MIL-H-83534(USAF)
AMENDMENT 1
25 October 1993

MILITARY SPECIFICATION

HEADSET-MICROPHONE, MONAURAL, LIGHTWEIGHT, INTRA-AURAL
GENERAL SPECIFICATION FOR

This amendment forms a part of MIL-H-83534, dated 1 September 1989, and is approved for use by the Department of the Air Force and is available for use by all Departments and Agencies of the Department of Defense.

FIGURE 15. Transmit response envelope."

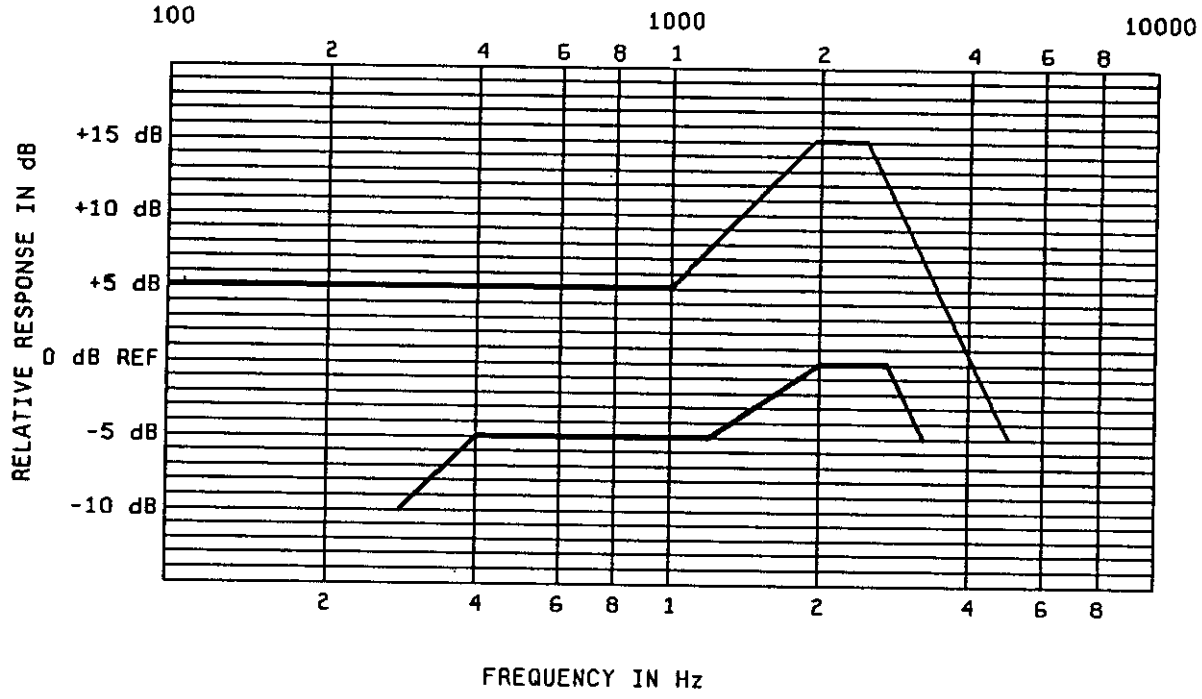
FIGURE 15, delete and substitute:
"

NOTE: The response curve shown is typical and may 'float' within the envelope.

FIGURE 16. Receive response envelope, intra-aural headset with and without volume control."

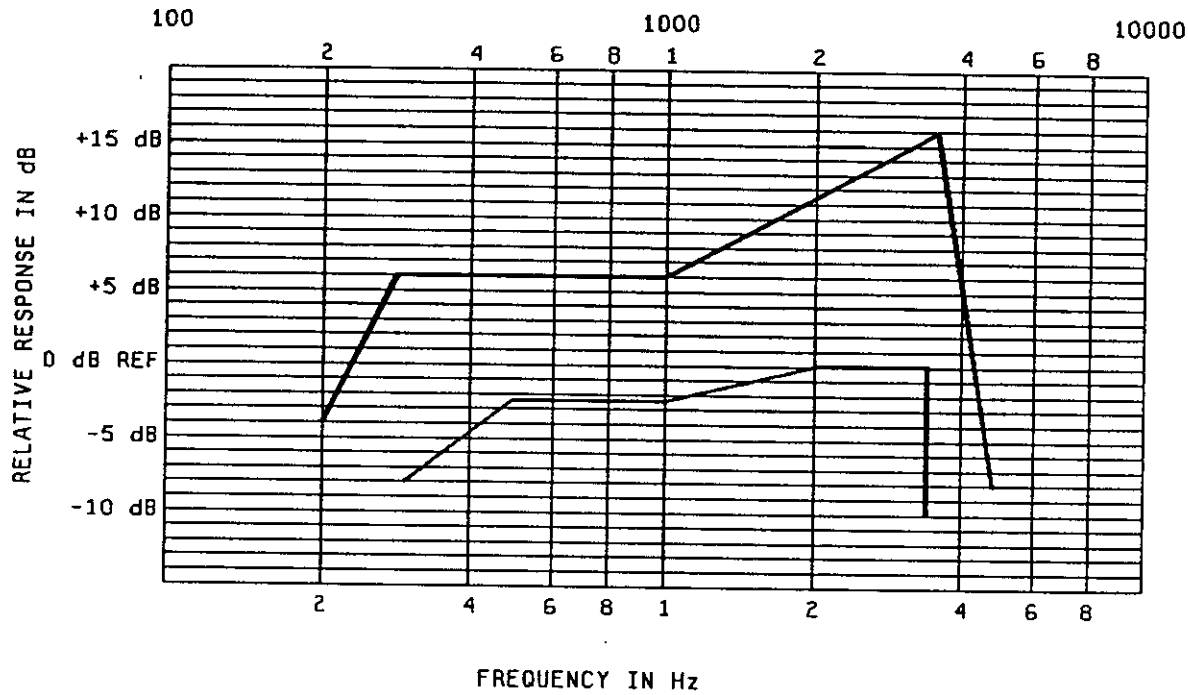
FIGURE 18, delete and substitute:
"

NOTE: The response curve shown is typical and may "float" within the envelope.

FIGURE 22. Input impedance test circuitry. "

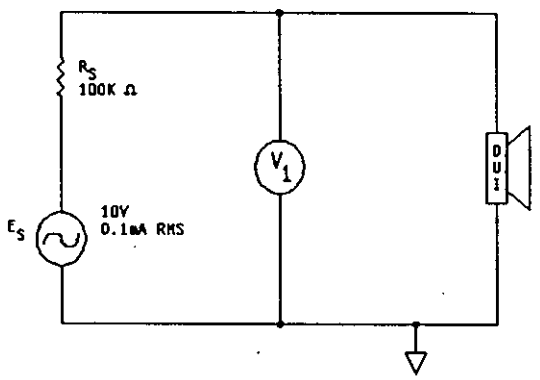
4.8.21, delete and substitute:

"4.8.21 Input impedance. Receiver impedance shall be determined to be the average of measurements taken at 500 Hz, 1,000 Hz, and 2,000 Hz. Each measurement shall be taken using the constant current method described in figure 22."

NOTES:
1. Constant current generator may be made with oscillator in series with 100 ohm resistor. Other values of E_s may be used (3.0 V_{RMS} min.). Then

2. Do not use ammeter to set current. Use floating voltmeter (true RMS) across R_S to avoid ground loops
3. Example calculation: V_1 is 30 mV for 300 ohms Z and V_1 is 600 ohms Z.
4. All tolerances are ±1%.
